HyNet Hydrogen Production Plant 1 – Technical Note

EPR Response 21 - Risk assessment for emissions from the flare

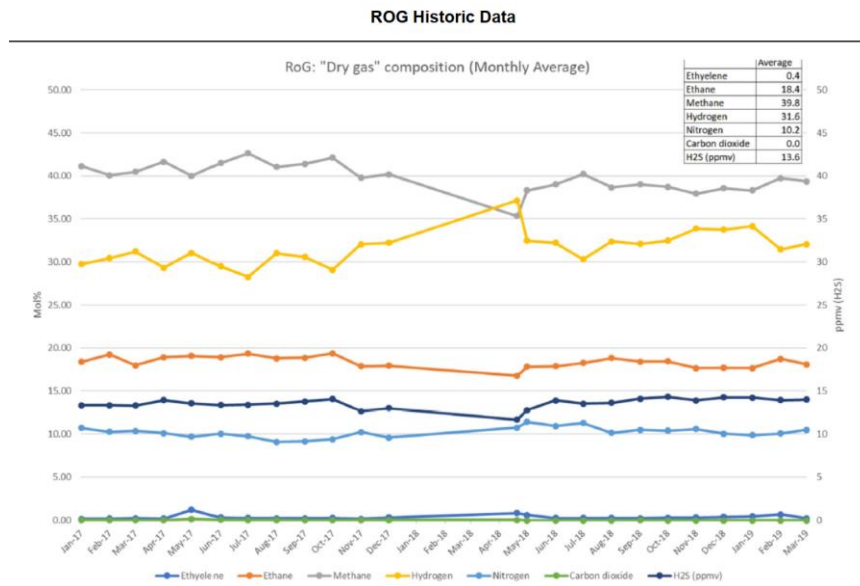
Provide a quantitative risk assessment for the emissions of sulphur compounds from the combustion of off-gases from the flare based on our web guidance <https://www.gov.uk/guidance/air-emissions-risk-assessment-for-your-environmental-permit> and Environmental permitting: air dispersion modelling reports - GOV.UK (www.gov.uk), or provide additional justification and evidence in support of your proposal not to carry out a quantitative risk assessment.

Notes: The application states that 'Periodic short-term flaring of gas with an elevated sulphur content is conceivable' (ref. 2.3.37 of the Application Supporting Document), whilst the area is within an AQMA for SO₂. Based on the application, we don't have enough information to concur with the conclusion of the qualitative assessment presented in section 7.3.3 of the Permit Application Supporting Document that the impacts from emissions from the flare are negligible.

As shown by the recent chart below of the compositional analysis for the ROG stream, the sulphur content is reasonably stable between 12 ppmv and 15ppmv. Therefore, the value at which the ROG stream flow is set at to prevent higher

levels of sulphur in entering the Hydrogen Production Plant (HPP1) shall be at 20ppmv (final value set at commissioning and after operational performance is completed), this set value shall close isolation valve 10-700-AAI-XZV-0003.
